#### ANN ARBOR HISTORIC DISTRICT COMMISSION

#### Staff Report

**ADDRESS:** 318 West Liberty Street, Application Number HDC13-213

**REPORT DATE:** December 12, 2013

Proposed front setback

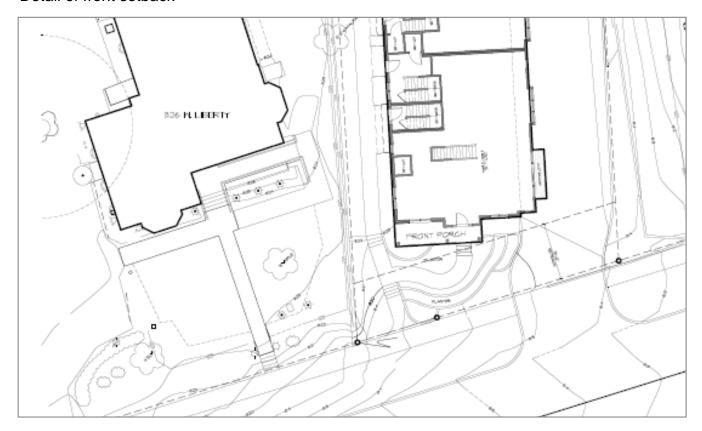
- 5. Staff's biggest concern is about the historic relationships of buildings on this block. The existing carwash (and the house that preceded it) has a front yard setback similar to the three historic homes to the west. The proposed design pushes the front of the condo about 30' in front of this historically established setback line, which is measured perpendicular to Liberty Street. The illustrations on the next page show the established front setback on a 2010 aerial photo, an aerial showing the building superimposed, and a site drawing of the proposed building footprint. The latter two are from the application attachments.

Both the Secretary of the Interior's Guidelines and the Ann Arbor Historic District Design Guidelines directly address historic relationships between buildings, and established setbacks and alignment patterns. The front of the building needs to be moved back significantly to follow the existing pattern of front yard setbacks.

When walking or driving west on West Liberty from downtown, the Brehm House next door would be completely obscured by this building, and the front porch wouldn't be visible, until passersby are directly in front of the new condo building. By following the established front setbacks, the Brehm House will still be mostly obscured, but the front elevation will remain visible from points much farther to the east.

Modifications are necessary to the materials, design, and placement of the structure before it will meet the Secretary of the Interior's Standards and Guidelines and the Ann Arbor Historic District Design Guidelines. Staff does not recommend approval of this application.
